Modifikationskit für Fokus- und Radial-regelkreis für A730
(Nachrüstsatz 20.050.730.01)
Modification kit for focus- and radial control circuit for A730
(Up-date kit 20.050.730.01)

SI 127/89 d/e 10.85.7030

Einführung neuer Servoelektronik
Introduction of new Servo electronics

SI 150/91 Order Nr. 10.85.7260 (Ed. 1191)

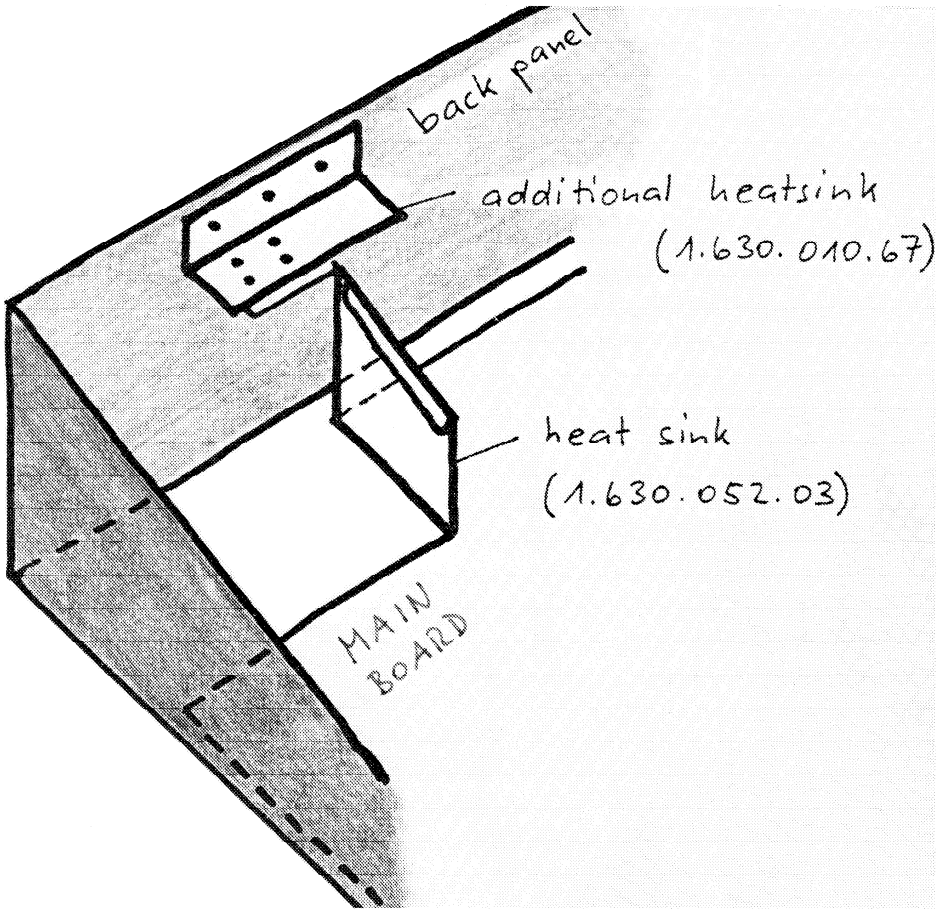
- Das Kühlblech (1.630.052.01) vom Board lösen (2 Schrauben, 4 Clips für Spannungsregler) und durch 1.630.052.03 ersetzen.
  ACHTUNG: Auf festen Sitz der Clips auf dem Kühlblech achten!

- Mit der Bohrlehre (10.010.001.41) die 3 Bohrlöcher an der Rückwand des Gehäuses markieren. Anschliessend Bohrlehre entfernen und die Löcher (3.5 mm) bohren.
  ACHTUNG: Bohrspäne restlos aus dem Gehäuse entfernen (wegen Kurzschlussgefahr)

- Kühlwinkel (1.630.010.67) und Kühlblech (1.630.052.03) miteinander verschrauben (Schrauben 21.53.0354). (Zwischen die Verbindungsstellen der einzelnen Blechteile ist etwas Wärmeleitpaste zu streichen). MAIN BOARD ins Gerät installieren und schliesslich den Kühlwinkel an der Rückwand von aussen mit den Schrauben (1.010.025.21) festziehen (siehe Zeichnung).

MAIN BOARD 1.630.052.21→23
DECODER / MODULATION DETECTOR SECTION

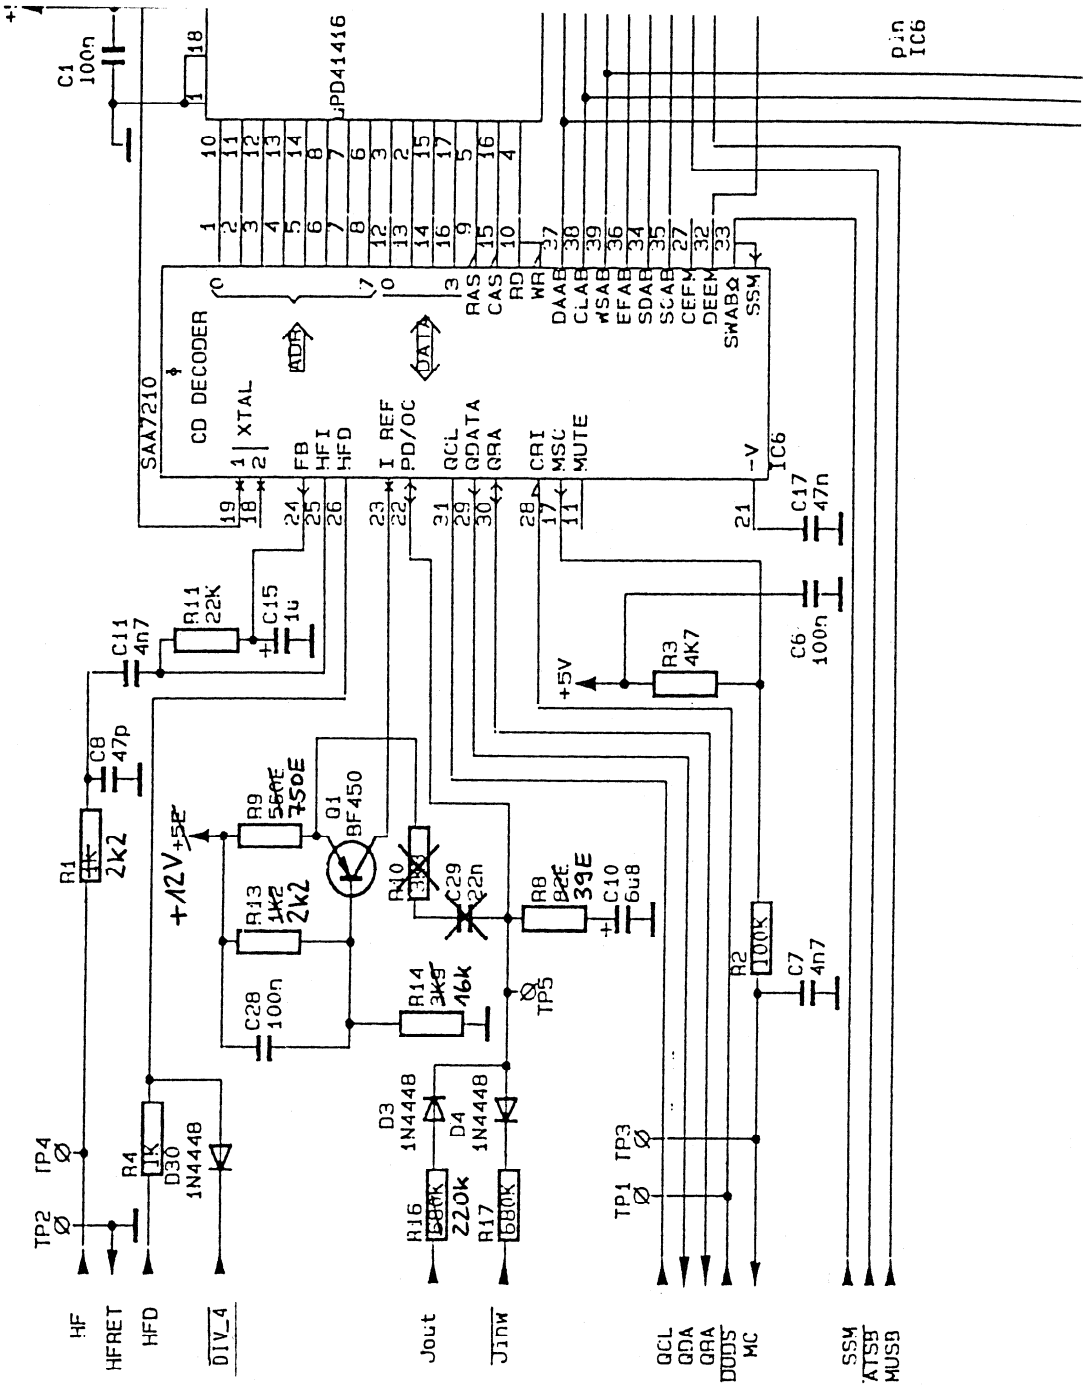
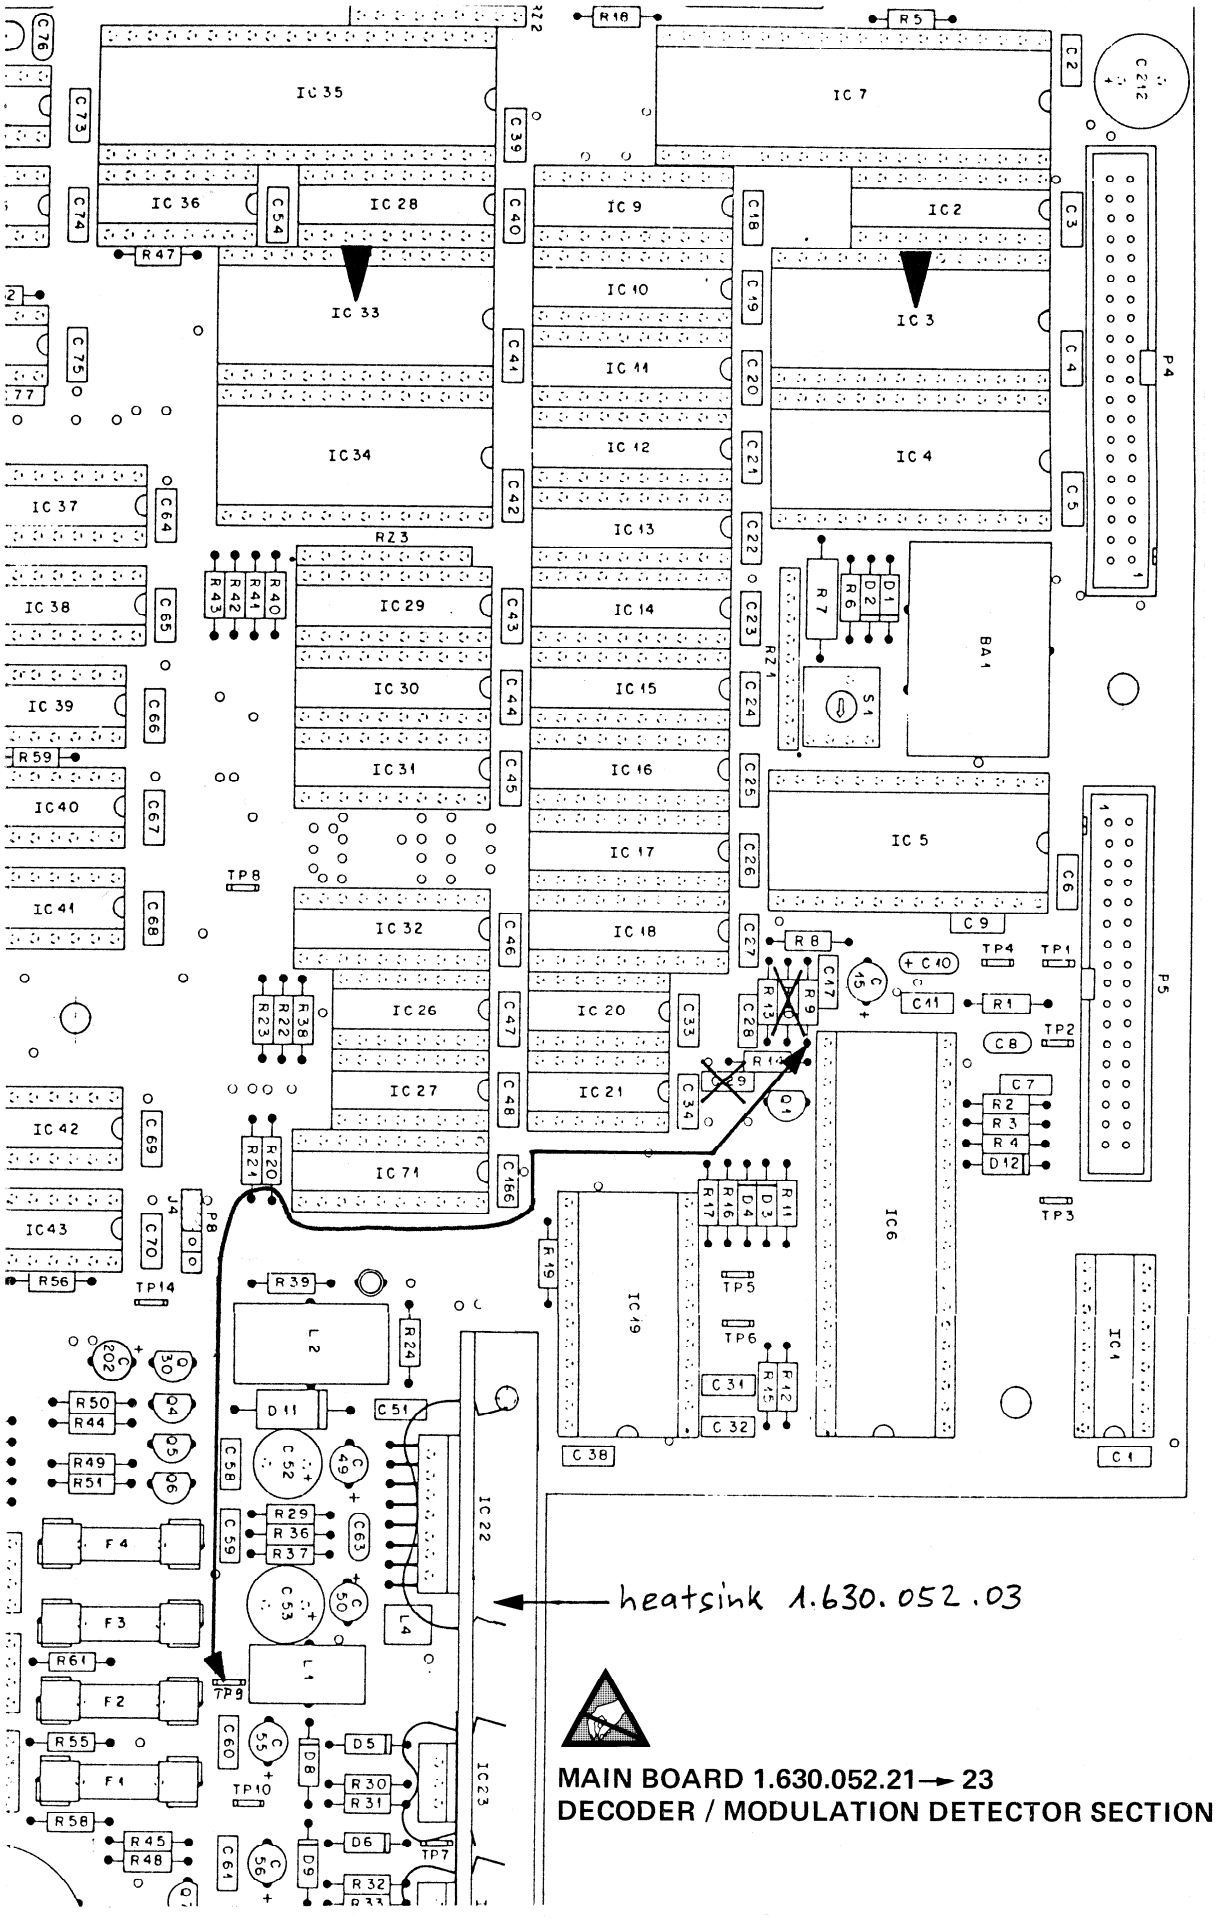
- Remove MAIN BOARD from the player
- Unsolder and remove R10 (3k3) and C29 (22n)
- The following components have to be changed:

- Replace potentiometer R147 by 4k7 resistor (57.11.3472) --> increased amplification in the monitor circuit

- IC 3 (1.630.065.20) to be replaced with 1.630.065.22 (CONTROL SOFTWARE)
  - IC 33 (1.630.066.20) to be replaced with 1.630.066.23 (SERVO SOFTWARE)

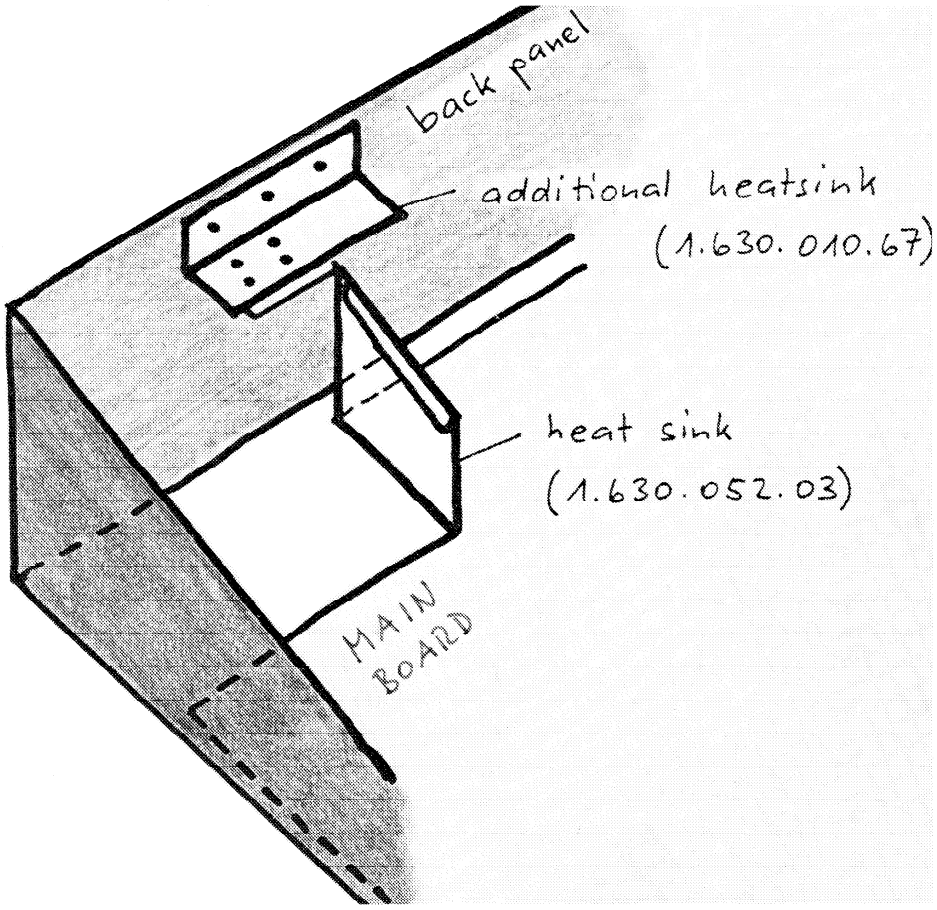
- Remove heat sink (1.630.052.01) from the print (2 screws, 4 clips for voltage control) and replace with 1.630.052.03.
  ATTENTION: Ensure tight seating of the clips on the heat sink!

- Using drilling template (10.010.001.41) mark the 3 holes on the rear wall of the case. Then remove drilling template and drill the holes (3.5 mm).
  ATTENTION: Make sure to remove all drilling chips from the case to avoid the risk of short circuits.

- Screw heat sink (1.630.010.67) to heat sink (1.630.052.03) with screws 21.53.0354. (Apply thermal joint compound at the points of contact between the heat sinks). Reinstall MAIN BOARD into player and fasten the small heat sink 1.630.010.67 to the rear wall with screws (1.010.015.21) from the outside (refer to drawing).

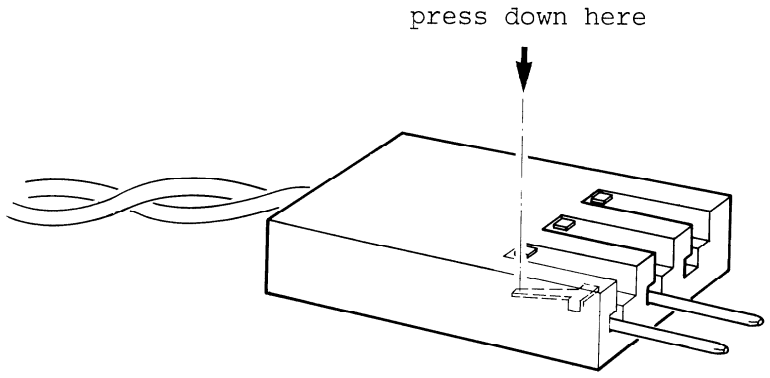
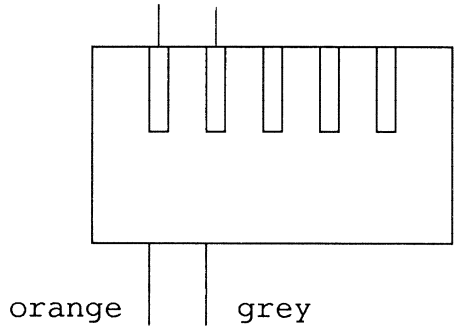
Pull the grey and orange wires (connection to the lock-solenoid) from the plug's shell by slightly pressing down with a screw driver the locking tongues of each wire (see drawing).

Bend the locking tongue of the grey and orange wire into their original position and put them according to the drawing below into the 5-pole plug-shell. Make sure the pins are locked.

MAIN BOARD 1.630.052.23

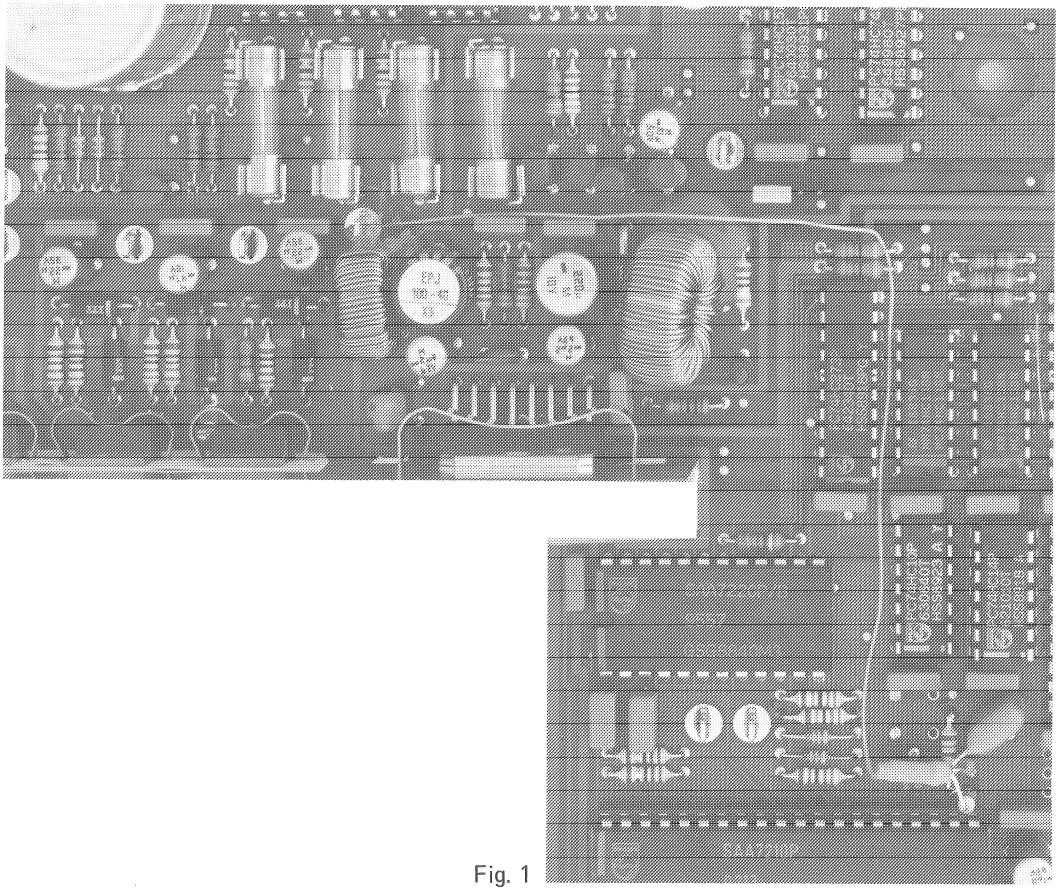
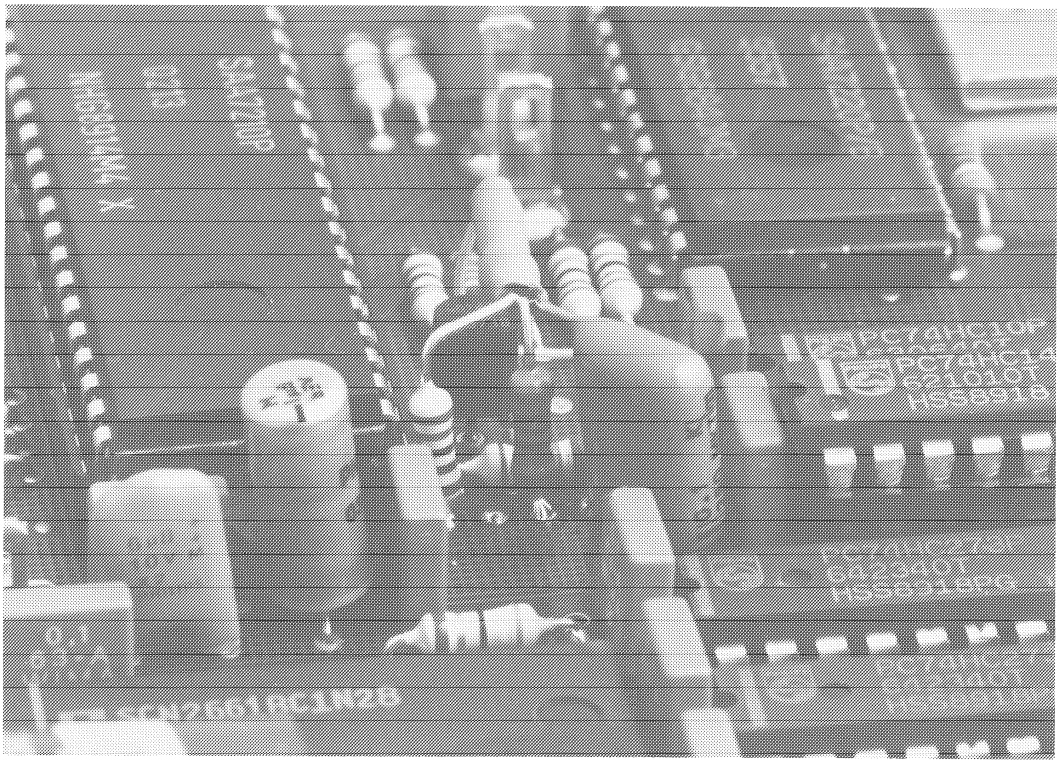
R9, R13 und C28 inkl. wire wrap Draht sind vorgefertigt und müssen gemäss Fig. 1 und Fig. 2 auf Seite 18 eingebaut werden. Der Draht wird also auf TP9 (+12 V) geführt.
